Proposed Residential Development
Land East of Lower Pennington Lane
Lymington
Application ref: 22/11424

Transport Review of
Planning Application Submission

February 2023

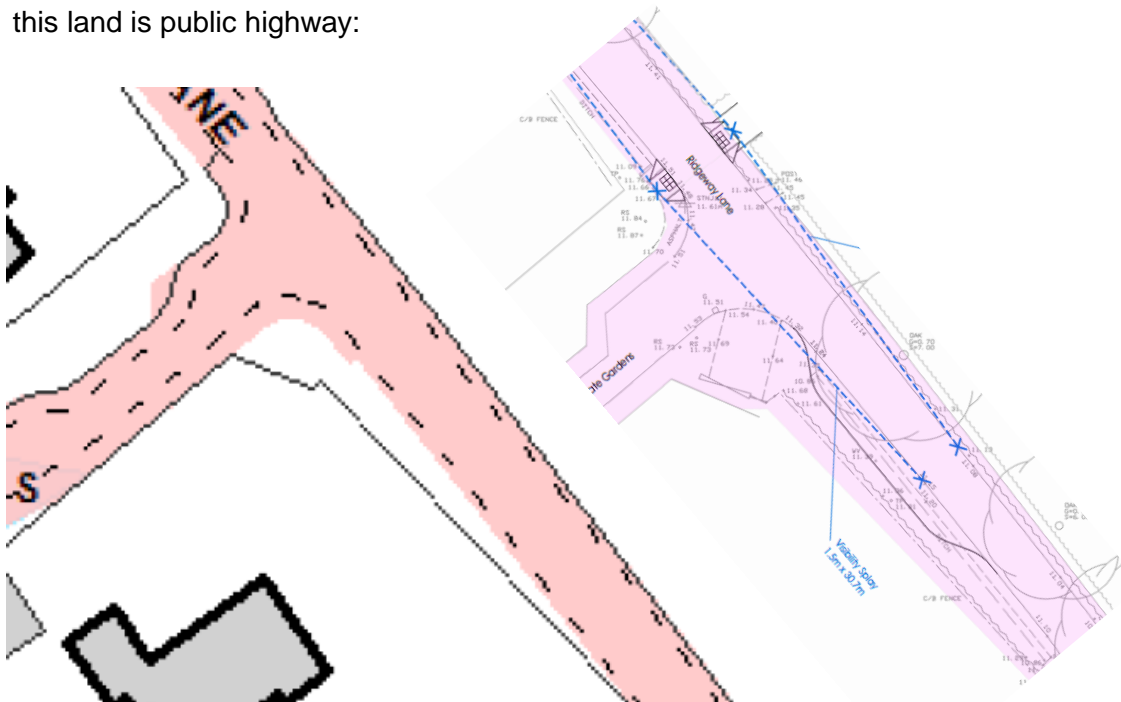
- 2.4.4 Two passing bays are proposed on Ridgeway Lane, the northern passing bay is proposed just south of Forest Gate Gardens and is shown within highway land (below right). However, the highway records provided by HCC (below left) show that not all of this land is public highway:

- 2.4.5 Whether or not the developer is able to provide the northern proposed passing bay on Ridgeway Lane on third party land is not clear and the works are outside the application red line. There is also an existing ditch along this section of Ridgeway Lane which would need to be taken into consideration and further questions whether this passing bay is achievable.
